Amendment to the Drawings:

FIG. 3

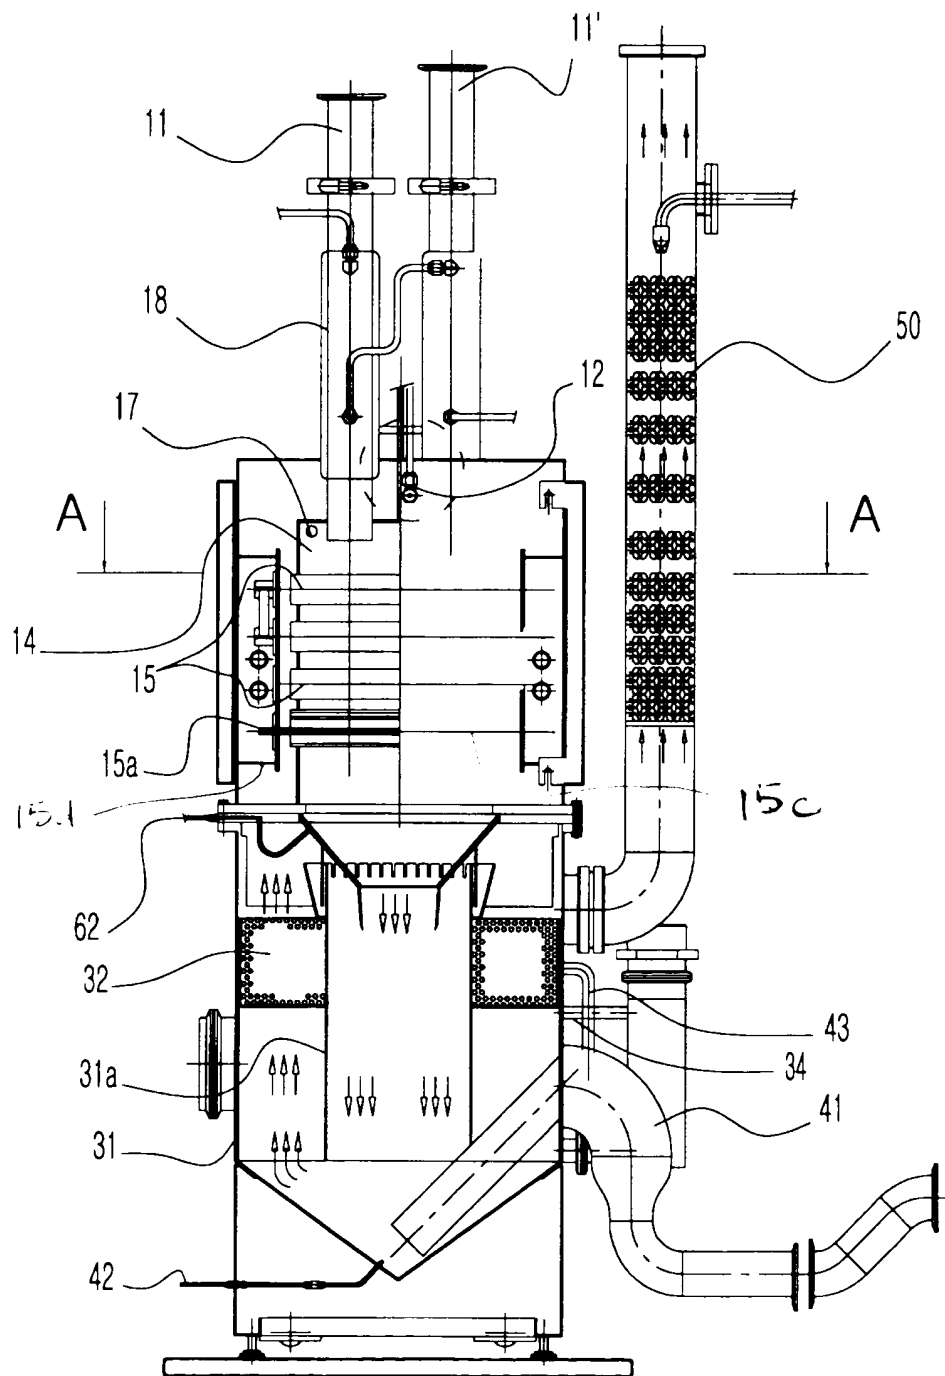
As shown on the attached Drawings, reference characters "15c" and "15d" were added to FIG. 3 to point out the electrical power conductor and clamp components, respectively. Reference character "15d" was also added to FIG. 4 to illustrate the relationship between the clamp (15d) and nitrogen nozzle 16. Support for the amendment to FIGS. 3-4 may be found in the Substitute Specification (see, amended paragraph above) and in dependent claim 12, as originally filed. As such, the amendments to the Drawings do not introduce new matter.
